Service Letter No. 472 (Supersedes No. 452)

SUBJECT: B. F. Goodrich Service Bulletin No. E-65-30
(Conduit Installation Modification)

MODELS AFFECTED: PA-23-250 and PA-E23-250 (six place) Aztec C's

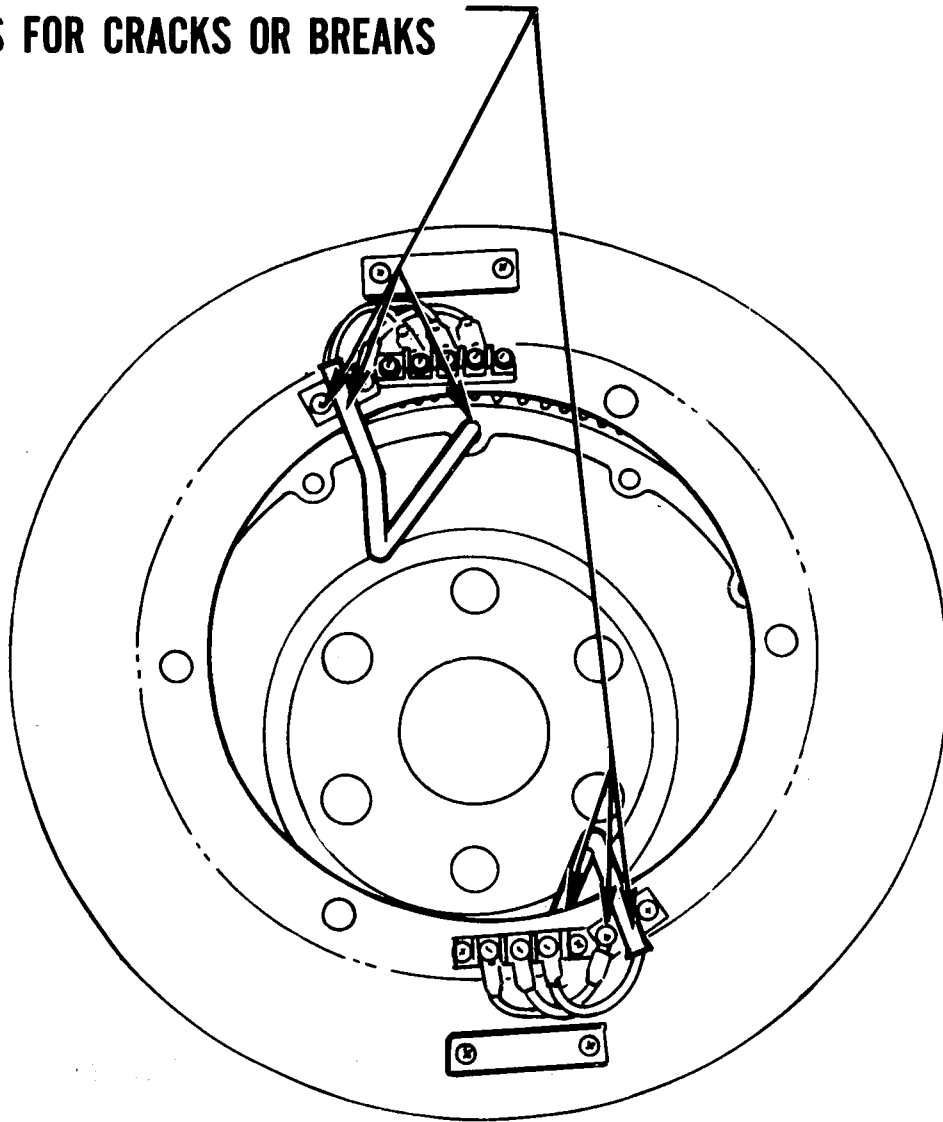
Conduit installation modification kit 757 017 contains the necessary material and instructions to accomplish this modification, however, it is requested that the conduits, Piper part number 753 922 (B. F. Goodrich part number 3E1388 or 3E1388-1) be inspected for possible cracks and if a crack is found the conduit be replaced before the subject kit is installed. (See sketch on reverse side of this letter.)

-includes rubber spacer

**CHECK AT THESE ATTACHMENT
POINTS FOR CRACKS OR BREAKS**

All Aztec C aircraft with B. F. Goodrich Electrical Propeller De-Icer Systems installed, as indicated above, must have modification kit 757 017 installed to prevent possible failure of B. F. Goodrich conduits, Piper part number 753 922 (B. F. Goodrich part number 3E1388 or 3E1388-1).
